**WATER PERMIT NO. 2626-2**

### Application For Permit To Appropriate Water For Irrigation

**RECOMMENDATION OF CHIEF ENGINEER FOR WATER PERMIT  
APPLICATION NO. 2626-2, IRAM**

WATER PERMIT APPLICATION NO. 2626-2  
IRAM  
FEBRUARY 15, 2008

Figure 1. Hydrograph of an observation well completed into the Inyan Kara aquifer approximately seven miles east of the well site proposed by Application No. 2626-2

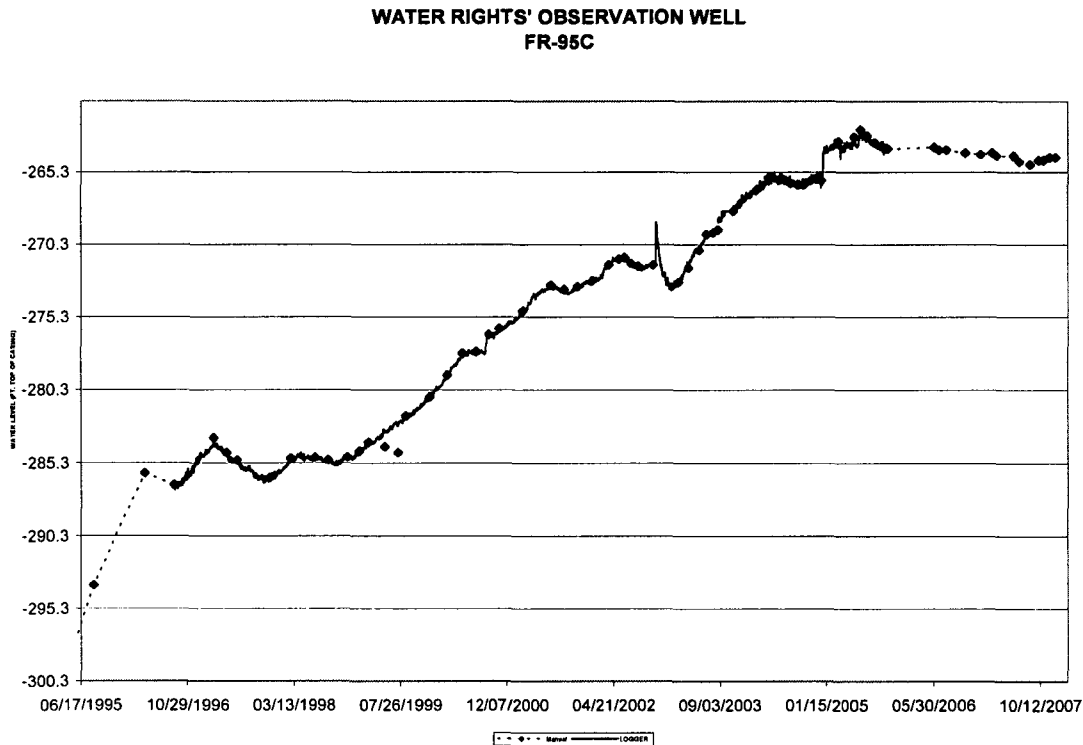
The hydrograph documents that the water level of the aquifer has fluctuated, and in general, has risen about 36 feet over the period of record. It is clear from the data that the aquifer recharges readily (Water Rights, 2008a). The hydrograph indicates water is available for this appropriation.
